Product Change Notice (PCN)

PCN Number: **PCN-0451185R-01**

Product(s) Affected: PJ-050B

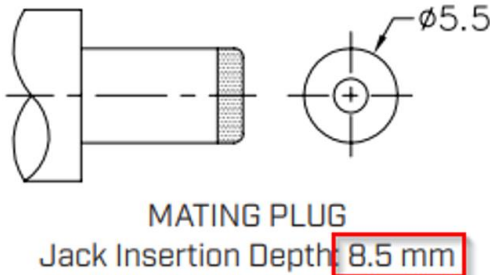
Description of Change: *Mechanical, electrical, and material changes as shown below:*

MATERIAL	PLATING
center pin	copper	nickel
terminal 1	brass	tin
terminal 2	copper alloy	tin
terminal 3	brass	tin
plastic	PBT

MATING PLUG
Jack Insertion Depth: 8.5 mm

DESCRIPTION	MATERIAL	PLATING/COLOR
center pin	copper alloy (H65)	nickel
terminal 1	C2680 t=0.35	nickel-silver
terminal 2	C5210 t=0.25	nickel-silver
terminal 3	C2680 t=0.30	nickel-silver
cover	PA9T UL94V-0	black
housing	PA9T UL94V-0	black

MATING PLUG
Jack Insertion Depth: 9.6 mm

Operating temperature range changing to -25C ~ +85C
